**Applicant requests a Special Exception under Section 2.16.050 Q (Carport over a Driveway) in an A-O/sc zone.**

TO: Zoning Board of Appeals Staff  
FROM: Javier De La Cruz, Building Plans Examiner, Building Permits and Inspections Section  
SUBJECT: CARPORT CASE FOR April 24, 2008 ZBA MEETING  
DATE: April 3, 2008

I have reviewed the plans for ZBA case 08-00026 located at 11963 Diego Rivera. The applicant is requesting a Special Q Exception under Title 2.16.050 for a carport over the driveway.

**ROOF FRAMING PLAN AND ELEVATION**  
 SCALE: 1/4" = 1'-0"

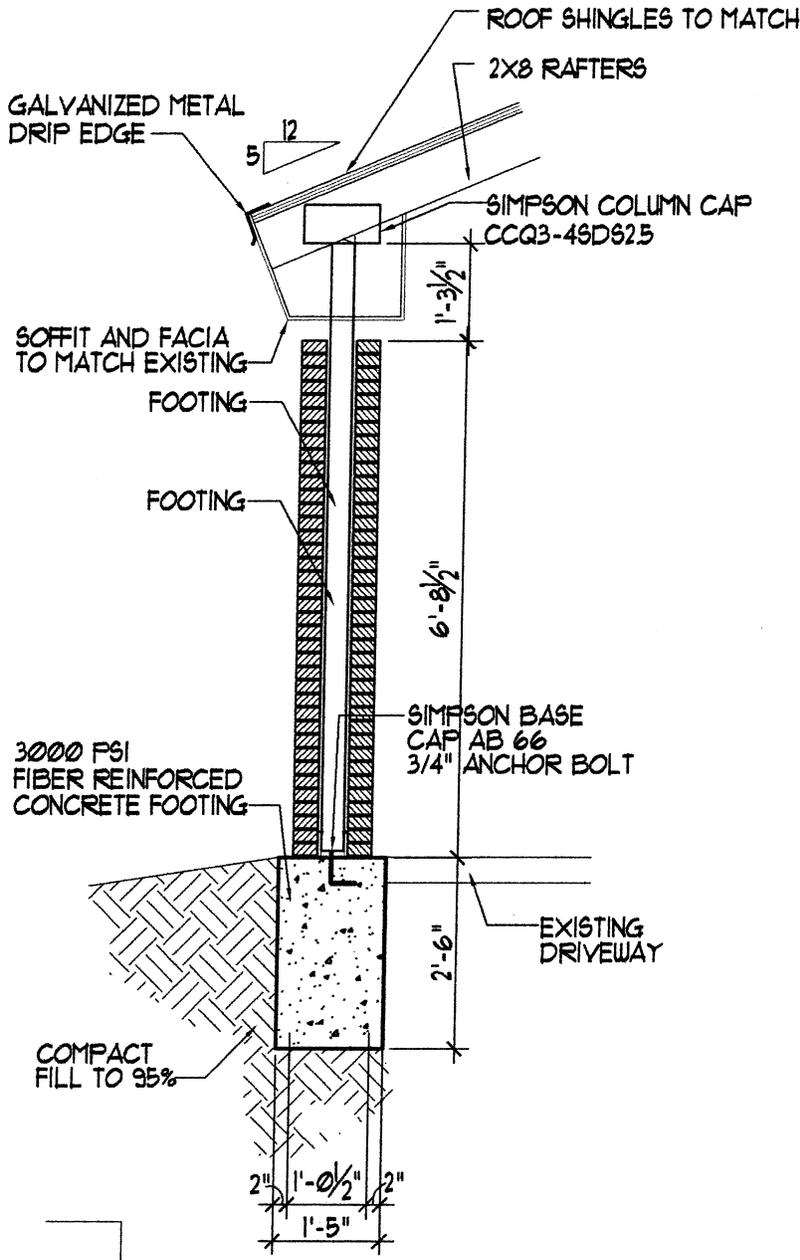
1. Over spanned ridge beam.
2. Specify highlighted beams
3. Beams above 4"x4" post need to be doubled
4. Rafters @ roof framing and wall section don't coincide
5. All sheets submitted must be sealed by Engineer
